UNITED STATES PATENT AND TRADEMARK OFFICE

Office Action Summary	Application No. 10/530,634	Applicant(s) HOLZ ET AL.	
	Examiner Leslie P. Cruz	Art Unit 2826

DETAILED ACTION

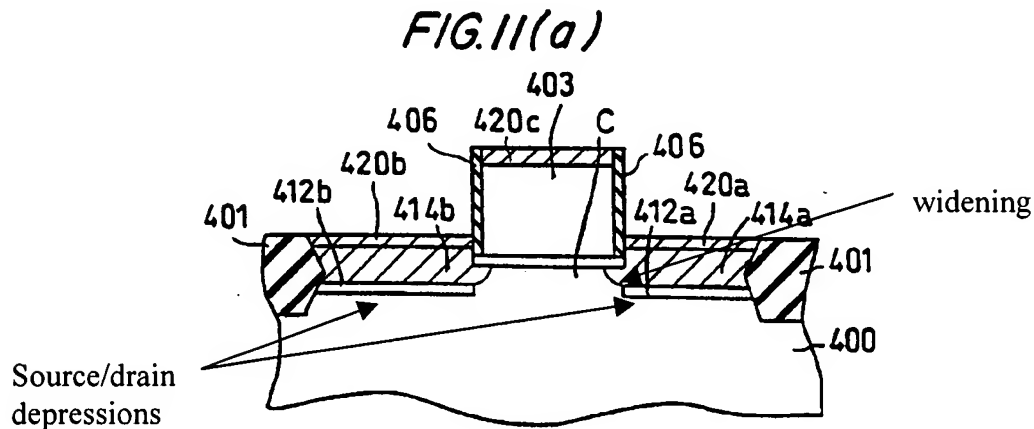
With respect to claim 1, Roberds (Figs. 1-6) discloses a field-effect transistor with local source-drain insulation, having a semiconductor substrate [16]; a source depression [30a] and a drain depression [30b], which are formed in a manner spaced apart from one another in the semiconductor substrate; a depression insulation layer [21a, 21b], which is formed at least in a bottom region of the source depression and of the drain depression; an electrically conductive filling layer [40a, 40b], which is formed for realizing source and drain regions and for filling the source and drain depressions at a surface of the depression insulation layer, wherein the electrically conductive filling layer has a seed layer [column 6 lines 11-12] for improving a

deposition in the source and drain depressions, the seed layer comprising silicon; a gate dielectric [14], which is formed at a substrate surface between the source and drain depressions; and a gate layer [12], which is formed at a surface of the gate dielectric, a widening [28a, 28b] with a predetermined depth for realizing defined channel connection regions.

1. Roberds (Figs. 1-6) further discloses the depression insulation layer has a depression sidewall insulation layer, which is formed in a sidewall region of the source and drain depressions but does not touch the gate dielectric.

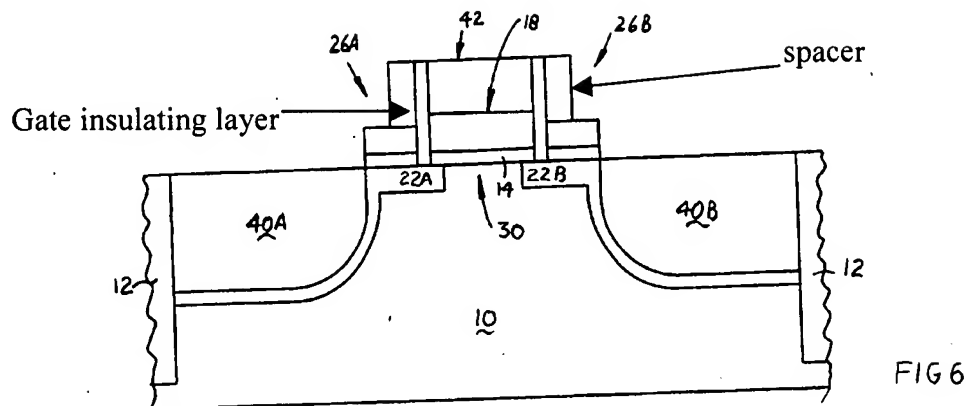
With respect to claim 1, Tsuchiaki (Figs. 11(a) - 12(c)) discloses a field-effect transistor with local source-drain insulation, having a semiconductor substrate [400]; a source depression and a drain depression [see figure below], which are formed in a manner spaced apart from one another in the semiconductor substrate; a depression insulation layer [412a, 412b], which is formed at least in a bottom region of the source depression and of the drain depression; an electrically conductive filling layer [414a, 414b], which is formed for realizing source and drain regions and for filling the source and drain depressions at a surface of the depression insulation layer, wherein the electrically conductive filling layer has a seed layer for improving a deposition

in the source and drain depressions, the seed layer comprising silicon [paragraph 0143]; a gate dielectric [402], which is formed at a substrate surface between the source and drain depressions; and a gate layer [403], which is formed at a surface of the gate dielectric, wherein the source and drain depressions have, in an upper region, a widening [see figure below] with a predetermined depth for realizing defined channel connection regions.

With respect to claims 7 and 8, Tsuchiaki discloses the field-effect transistor as claimed in claim 1. Tsuchiaki does not disclose that the field-effect transistor has lateral structures < 100 nm or that the source and drain depressions have a depth of approximately 50 nm to 300 nm. However, it would have been obvious to one of ordinary skill in the art at the time the invention was made for the field-effect transistor of Tsuchiaki to have lateral structures < 100 nm or the source and drain depressions have a depth of approximately 50 nm to 300 nm in order to miniaturize the device while suppressing the resistance. The specific claimed relative dimensions of the lateral structures or the source and drain depressions, absent any criticality, are only considered to be the "optimum" dimensions that a person having ordinary skill in the art would have been able to determine using routine experimentation based, among other things, on the desired adhesive strength, manufacturing costs, etc. (see Boesch, 205 USPQ 215 (CCPA 1980)), and since neither non-obvious nor unexpected results, *i.e.*, results which are different in kind and not in degree from the results of the prior art, will be obtained.

**FIG. 13**

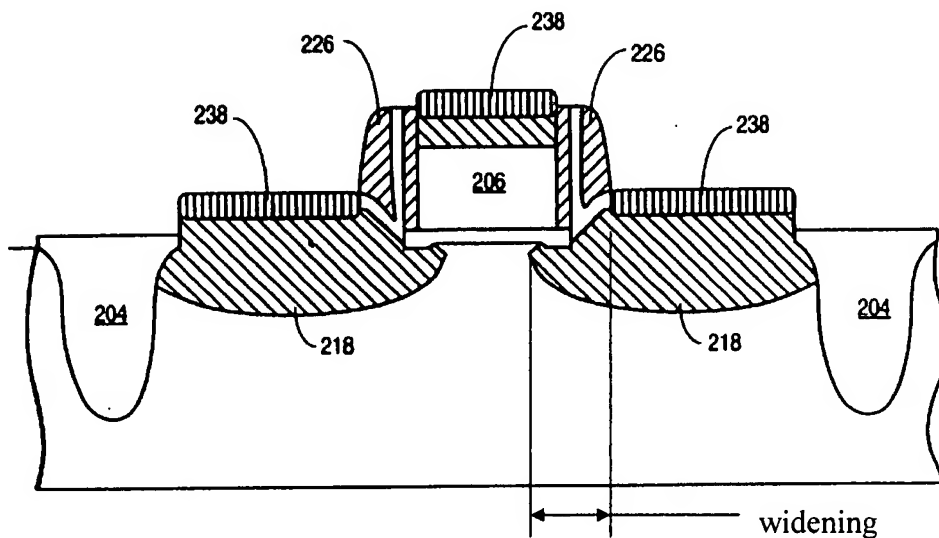
With respect to claim 23, Roberds discloses the field-effect transistor as claimed in claim 2. Roberds does not specify that a spacer comprises silicon nitride. Murthy (Figs. 8-14) discloses that it is well known for a spacer [326] to comprise silicon nitride [paragraph 0050]. It is beneficial for the spacer to comprise silicon nitride because of its resistance to wet etching steps. Therefore, it would have been obvious to one of ordinary skill in the art at the time the invention was made for the device of Roberds to comprise a spacer that comprises silicon nitride such as taught by Murthy, because of its resistance to wet etching steps.

With respect to claim 24, Roberds discloses the field-effect transistor as claimed in claim 2. Roberds does not disclose that a spacer extends into the widening. Murthy (Figs. 2, 8-14) discloses that it is well known for a field-effect transistor to comprise a spacer [213] that extends into the widening [244]. Murthy teaches that it is beneficial for a spacer to extend into the widening in order to further reduce the distance between the gate electrode and the electrically conductive filling layer, which would reduce an adverse capacitance [paragraph 0030].

Therefore, it would have been obvious to one of ordinary skill in the art at the time the invention was made for a spacer to extend into the widening in order to further reduce the distance between the gate electrode and the electrically conductive filling layer which would reduce an adverse capacitance.
